112 Lake Street - Kirkland, WA
 Continental Properties

DEVELOPMENT STANDARDS LIST
112 Lake Street South Mixed-Use Project
File No: DRV19-00461

Permit #: DRV19-00461

Project Name: 112 Lake Street Mix-Use

7. KWM Tenant Garbage Pick-up & Loading Access

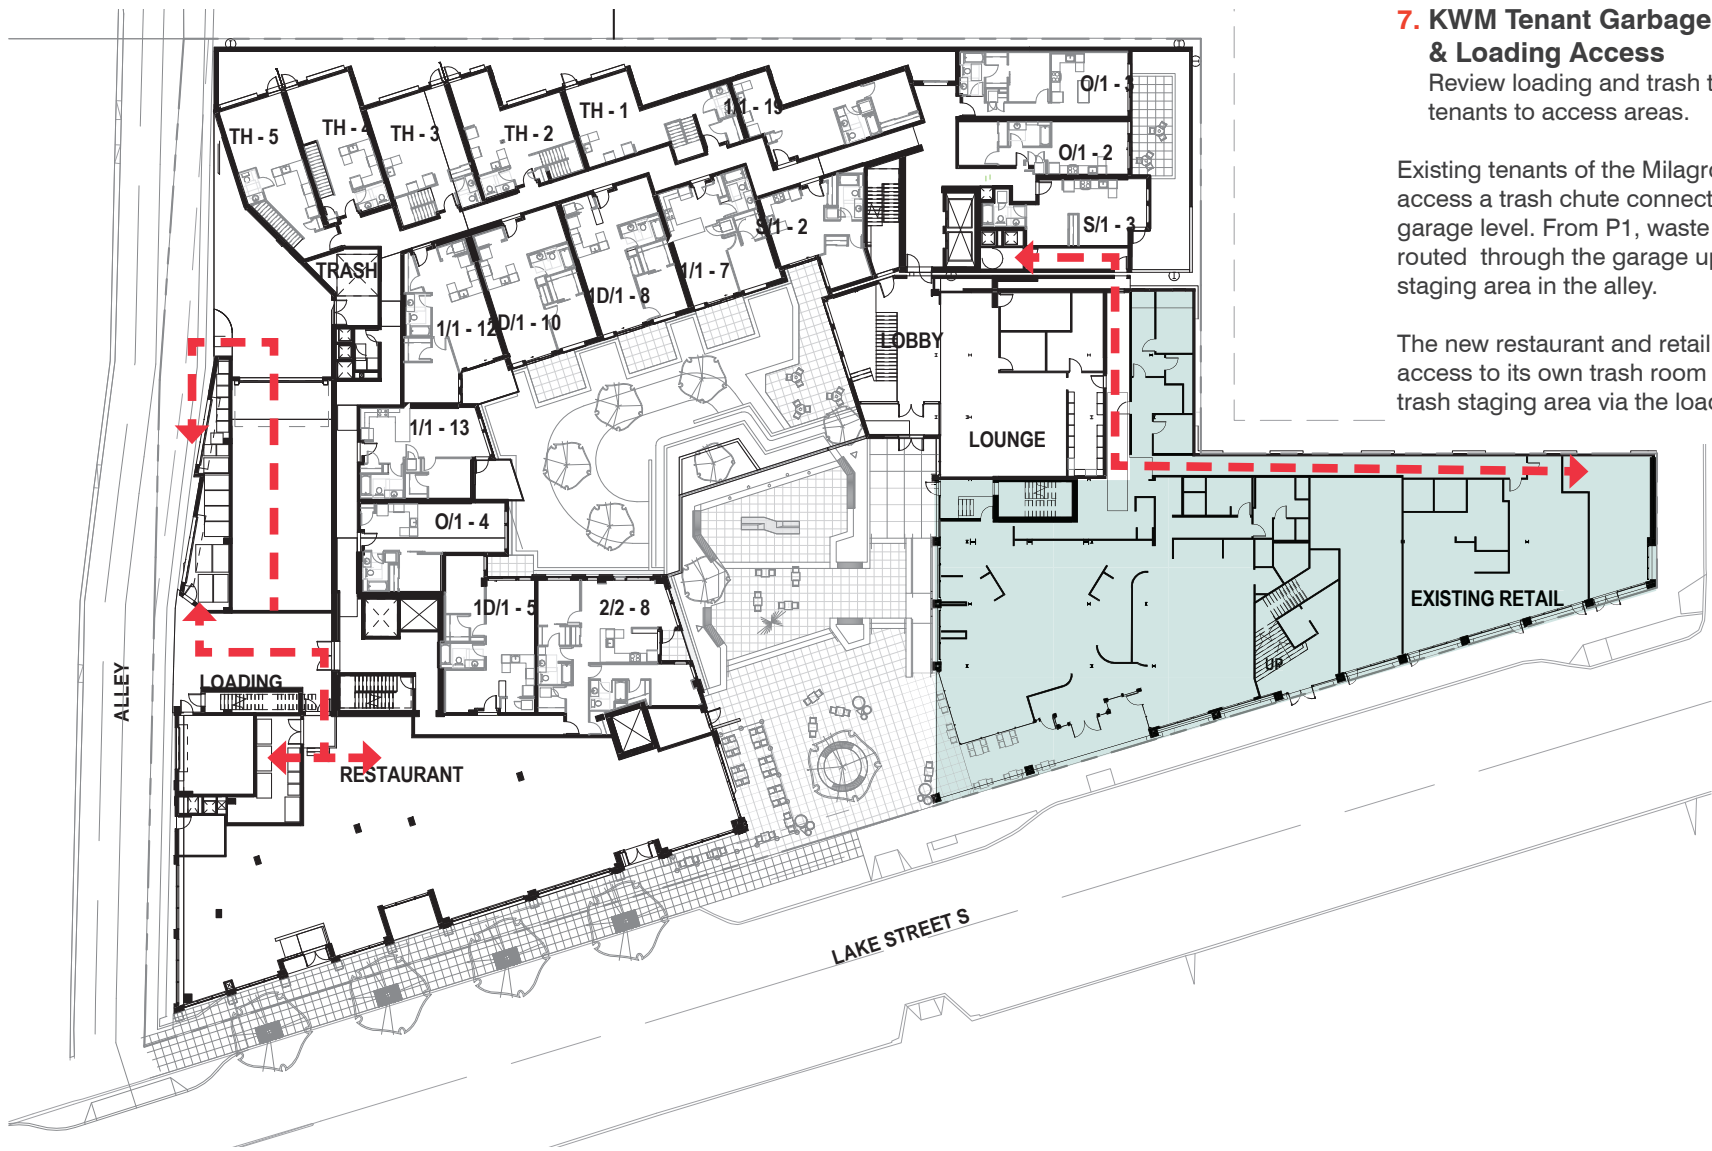
Review loading and trash to allow south tenants to access areas.

Existing tenants of the Milagro Building will access a trash chute connected with the P1 garage level. From P1, waste will be internally routed through the garage up to the trash staging area in the alley.

The new restaurant and retail space will have access to its own trash room and access the trash staging area via the loading dock.
